Visual Quality of a Chilliwack Cutblock

Complaint Investigation 060739

FPB/IRC/141

**Forest
Practices
Board**

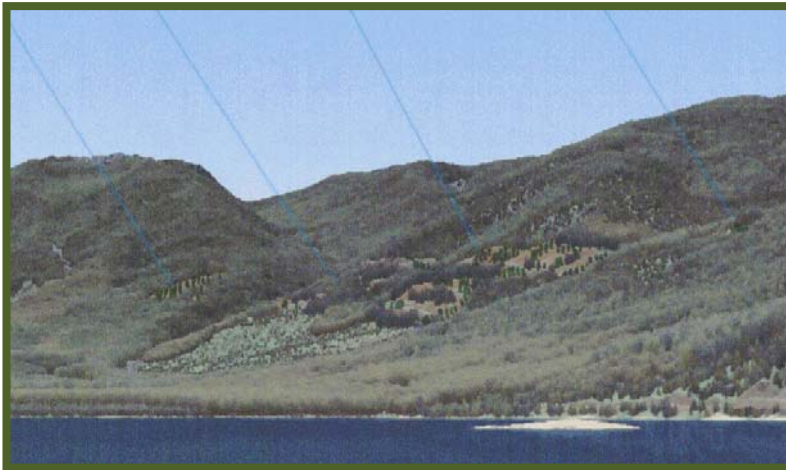
Blocks 39 and 40 are in a mid-slope position and are to be developed as small openings with individual (minor) and group (major) tree retention with an irregular feathered stand edge along boundaries. Edge treatment will create a series of irregular openings with little evidence of block edge. The most visible areas will be in the upper portions of block 39.

Cropped and zoomed picture of the VAP for Cutblock 39 and 40 from Kilby Beach viewpoint 1e – VAP, February 2006.

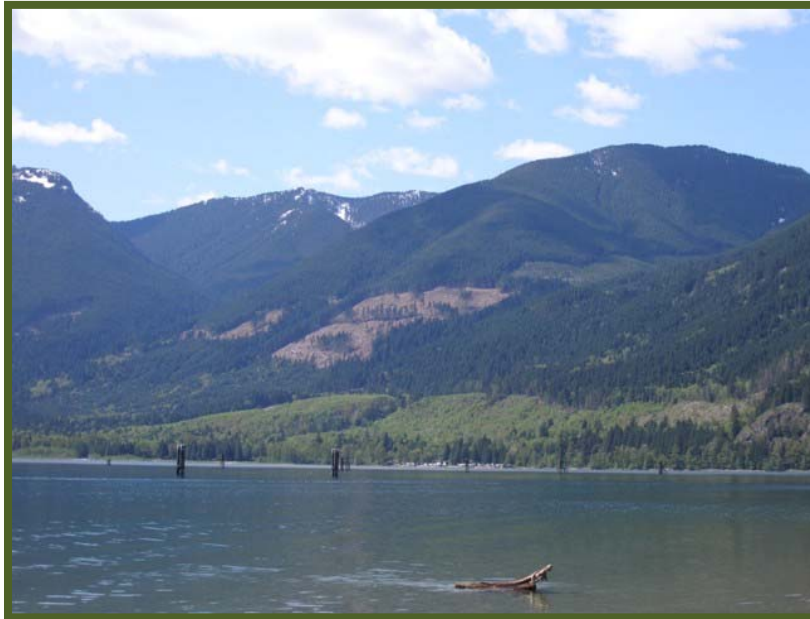
The acting district manager reviewed the VAP. Prior to approval, district staff and the licensee focused on reducing the percent alteration projections. The VAP projected a combined visual impact of the two cutblocks as 2.9 percent alteration on the landform. This would achieve the partial retention rVQC from all the viewpoints.

Even though the description of the projected visual condition was at odds with the percent alteration projections, blocks with good design characteristics can exceed the numbers and still fit the corresponding visual class. Accordingly, the district operating procedures specified that a licensee can exceed the numerical guidelines if the cutblocks have good designs.

District staff reviewed the submission for visual design. MFR staff told the Board that they examined the simulations from the Kilby Beach viewpoint and concluded that the cutblocks consisted of small openings following the lines of force. That is, the longer portion of the openings was orientated in the same direction as the lines of force. As well, the simulation and maps illustrated that the openings had varied spacing, were asymmetric, and somewhat organic in shape. The block boundaries were generally curved, the edges were to be feathered and the cutblock retained islands of timber. Staff concluded that the submission had the necessary elements of good design.
